Subject: Duke Energy Carolinas, LLC
William States Lee III Nuclear Station - Docket Nos. 52-018 and 52-019
AP1000 Combined License Application for the
William States Lee III Nuclear Station Units 1 and 2
Response to Request for Additional Information
Ltr# WLG2009.2-06

Lee Nuclear Station Response to Request for Additional information (RAI)

Reference NRC RAI Number: ER RAI-115

Figure 1. Location of Stained Soils

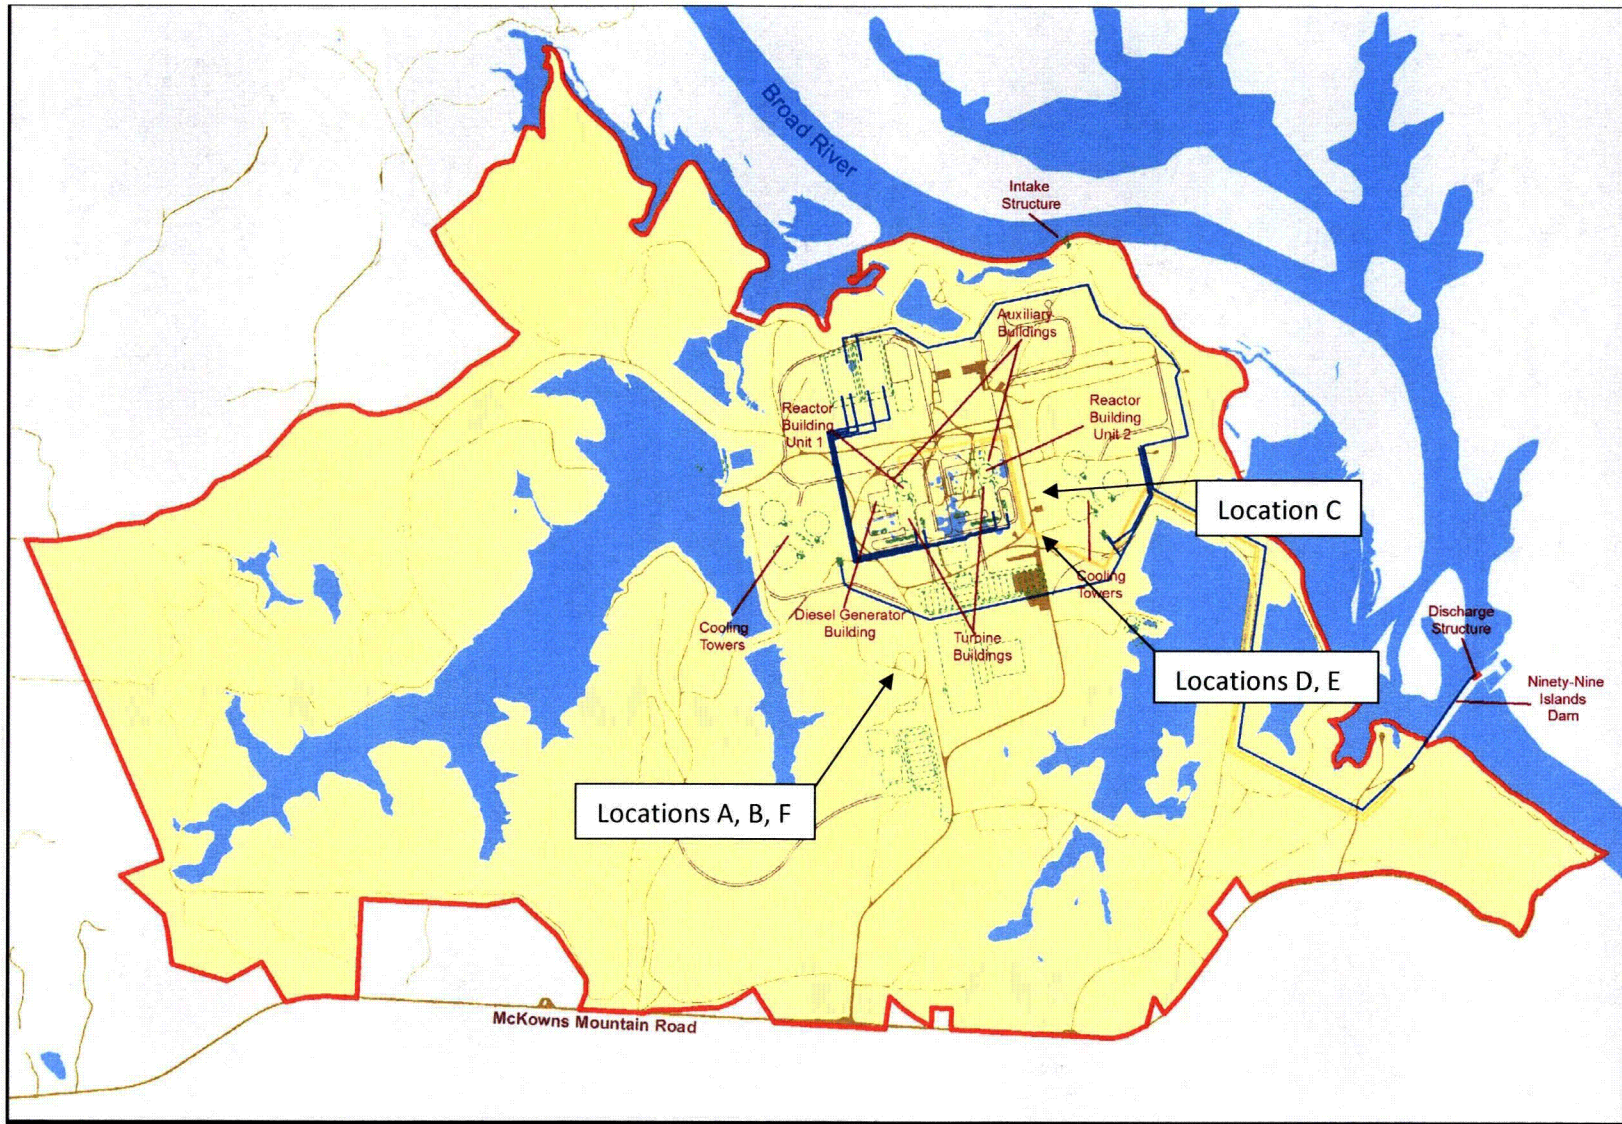
Identify the contaminants found in the stained soil, the location of the stained soils, applicable clean-up levels and/or their concentrations prior to and after site clean-up.

The response to RAI 67 discussed information on disposal of stained soil identified during the Phase 1 survey. The response did not identify the contaminants or provide details on the location of the stained soil or contaminant concentrations before and after clean-up.

Petroleum stained/impacted soils were excavated and disposed from various locations at the site based on visual observations. Concentrations of petroleum were not determined prior to soil excavation. Excavations were made at the following locations (see Attachment 115-1, Figure 1):

- Location A:** Large stained soil area immediately west of the Cherokee Site Motor Pool area.
- Location B:** Stained soil area at the northwest corner of the Cherokee Site Motor Pool area.
- Location C:** Small stained soil area on the east side (rear) of the Storage Shed.
- Location D:** Small stained soil area on the west side of the Cabinet Shop.
- Location E:** Small stained soil area on the east side of the Cabinet Shop.
- Location F:** Petroleum impacted soils beneath drums southwest of the Cherokee Site Motor Pool area.

For each of the locations indicated above and illustrated in Attachment 115-1, the affected soil was removed to the extent specified in South Carolina guidelines for contaminated soil. For Locations A through E, U.S. Environmental Protection Agency Methods 8260B and 8270C were used to confirm that no detectable volatile organic compounds remained. Because the depth of the excavation at Location F prevented collection of a sample without jeopardizing personnel safety, Location F was verified to be clean based on the lack of additional staining and the absence of perceptible petroleum odors. Petroleum contaminated soil was disposed in the Duke Energy - McGuire Nuclear Station landfill facility.
